# Citizen Request for Public Hearing – Construction Permit Regarding Allen-Harim Harbeson Facility Phase I Upgrade and Expansion Wastewater Facilities Construction Permit Application Public Comment and Public Hearing Request deadline September 24, 2015 Submitted to DNREC Division of Water, Surface Water Discharges Section

Neighborhood landowners, concerned citizens, and several environmental citizen organizations including Protecting Our Indian River (POIR) request a Public Hearing for the proposed construction permit for Allen-Harim Harbeson Facility Upgrade and Expansion (EPA ID DE000299; State Permit No. WPCC 3131F/76).

An initial technical review of the Final Design Summary of Wastewater Treatment System Upgrade and Expansion (Phase I) dated August 21, 2015, the engineering drawings, and other documents in the public file was made by Kathy J. Martin, PE (OK#18254) at the request of the citizens. The application was received August 21, 2015. DNREC requested publication of public notice on September 2, 2015 with a close of comment period on September 17, 2015. The public comment period was extended to September 24, 2015 due to difficulties in the public obtaining a full copy of

**Figure 4** – Close-up of southwest lagoon in 2005 showing extreme vegetation and floating plastic liner.

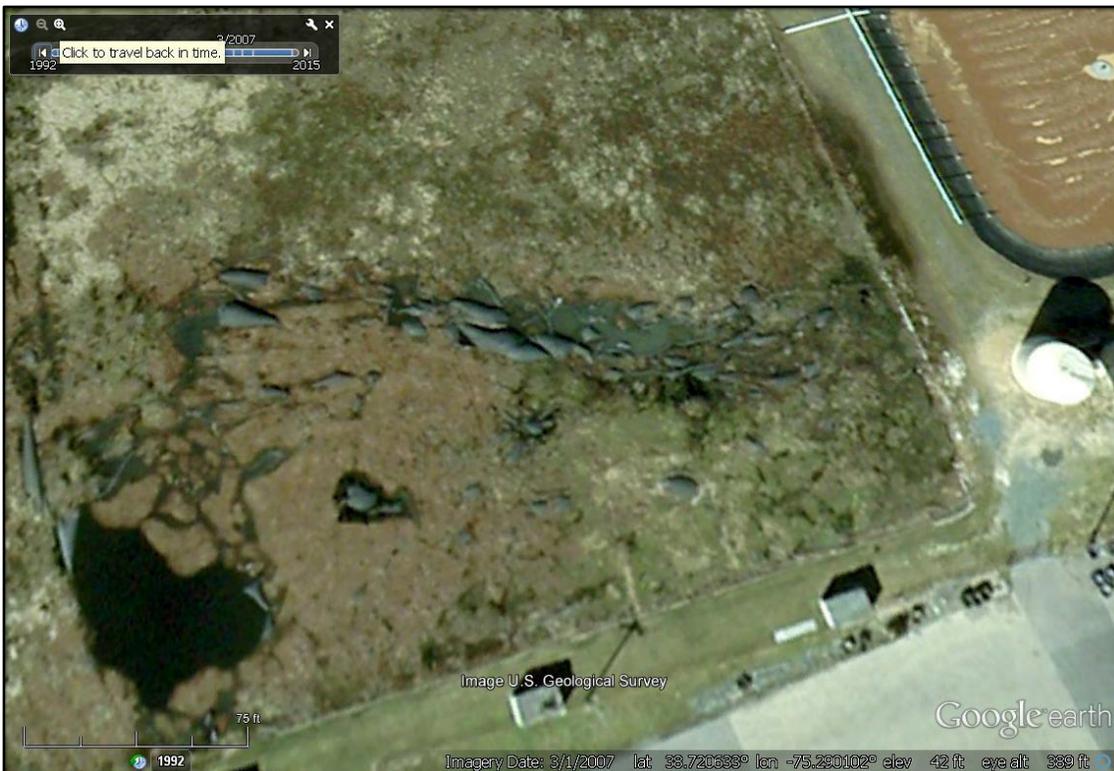
- How will DNREC determine whether or not the existing wastewater treatment system has contaminated shallow groundwater?
- Is the plastic liner in the west lagoon intact after it has been floating (whaling) for several years (see Figures 4, 5, and 6)?

- How will the new wastewater treatment system improve the conditions of the west lagoons with respect to vegetation and plastic liner integrity?
- Under what conditions would the facility have a peak flow rate of 4.0 million gallons per day as shown on page 4 of the Design Summary?
